Field campaign

Topic	Incorrect wheel bolt cap kits (SC25/06)
Market area	Bentley: worldwide (2WBE),China 796 VW Import Comp. Ltd (Vico), Beijing (6796)
Brand	Bentley
Transaction No.	2077217/1
Campaign number	ED36
Note	
Type	
US code

Figure 1 – 21" Twin 5 spoke (PR Code: C9N)

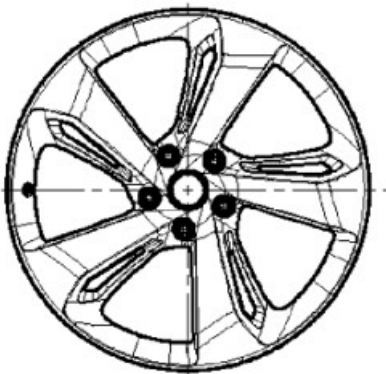
On all affected vehicles the wheel bolt cover cap kit supplied in the dealer kit bag for specific BY636 25MY vehicles (wheel style dependant) do not fit the wheel bolts.

Testing found that the cap kit 8w0.600.026.E was unsuitable and the caps do not fit on to the bolt.

The issue affects specific wheel styles only (PR code related). See images below.

To fix this Bentley has reverted to current cap kit 36A.600.026.B.

Figure 1 – 21" Twin 5 spoke (PR Code: C9N)

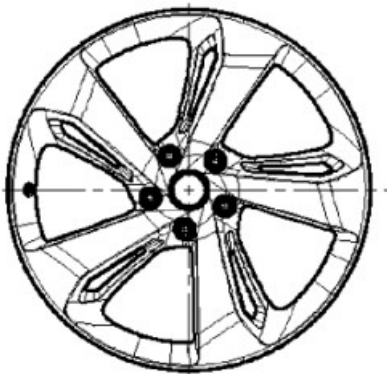
On all affected vehicles the wheel bolt cover cap kit supplied in the dealer kit bag for specific BY636 25MY vehicles (wheel style dependant) do not fit the wheel bolts.

Testing found that the cap kit 8w0.600.026.E was unsuitable and the caps do not fit on to the bolt.

The issue affects specific wheel styles only (PR code related). See images below.

To fix this Bentley has reverted to current cap kit 36A.600.026.B.
